**Fraser Planning Commission Agenda
City Council Chambers
33000 Garfield, Fraser, MI 48026
Monday, January 13, 2025 @ 7:00 p.m.**

Site Plan Review Summary

Site Plan Dated 12/19/2024
City of Fraser, Michigan

SITE ADDRESS / LOCATION 34625 & 34835 Utica Road- 03-11-31-202-002 & 03-11-31-100-049	APPROVING BODY Planning Commission	PUBLIC HEARING DATE N/A
STAFF REPORT CONTACT INFORMATION Building Clerk – Kayshe Johnson– (586) 293-3100 ext. 154 Planning Consultant – Lauren Sayre, AICP – (586) 293-3100 ext. 153	APPLICANT / PROPERTY OWNER Mister Car Wash, Applicant Good Will Co. Inc., Property Owner

ELEVATIONS

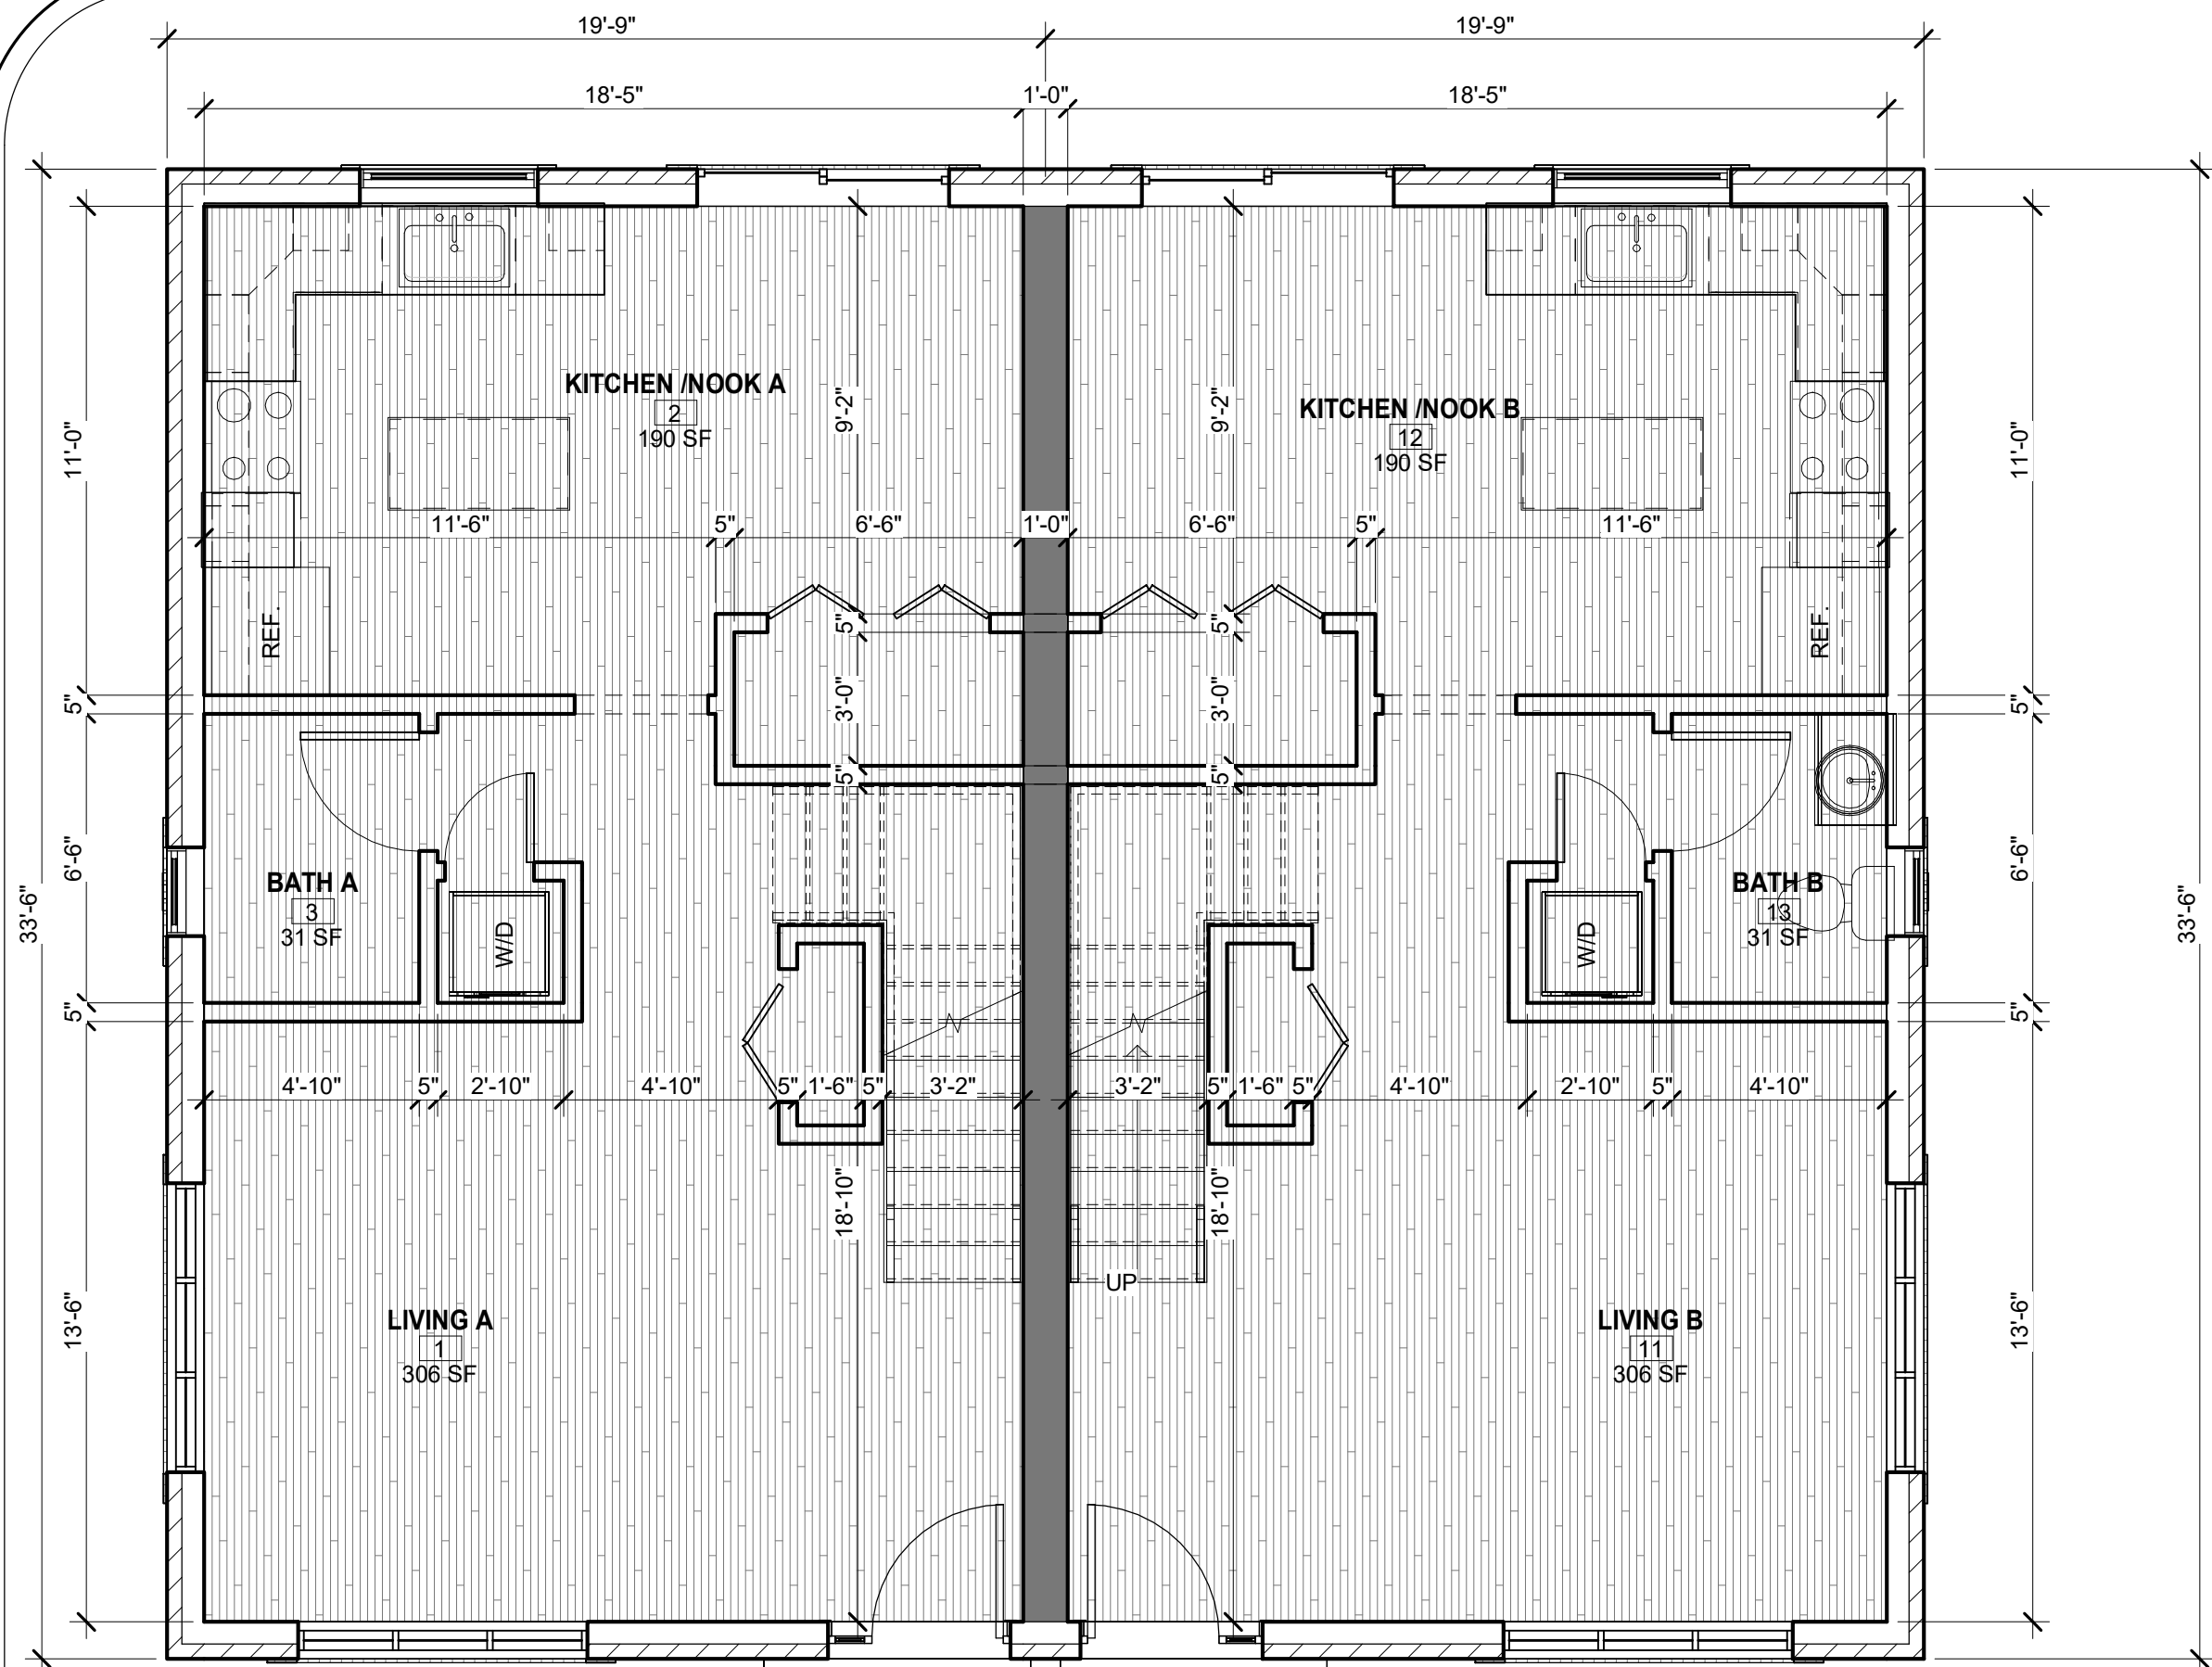
The elevations of the building are shown on Sheet A-2. The exterior of the building is proposed to contain a mix of brick and face brick, as well as vinyl siding and asphalt shingles. While there is a mix of materials, we would ask the applicant to consider the following design elements to improve the visual interest in the development. Please note that these are not required by the Zoning Ordinance but are being requested as a best practice.
